U.S. Serial No. 10/617,520
Page 6

Amendments to the Drawings:

**Figure 1****Figure 2**

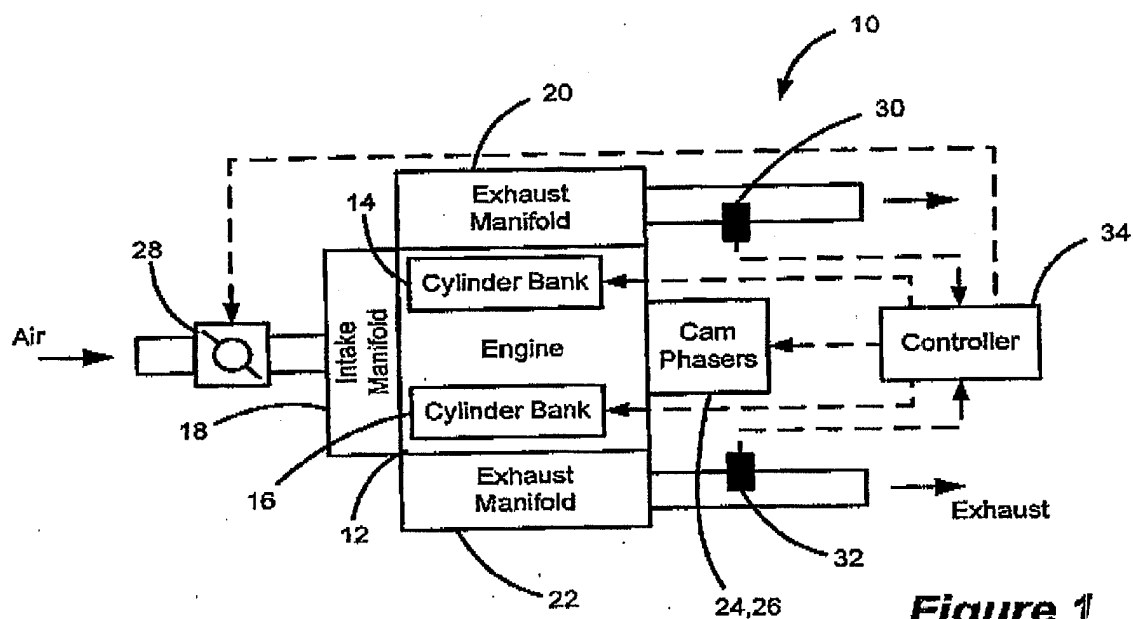
The attached sheet of drawings includes changes to Figure 1. This sheet, which includes Figures 1 and 2, replaces the original sheet including Figures 1 and 2. The reference numeral "18" has been changed to correctly identify the upper cylinder bank as - 14 - .
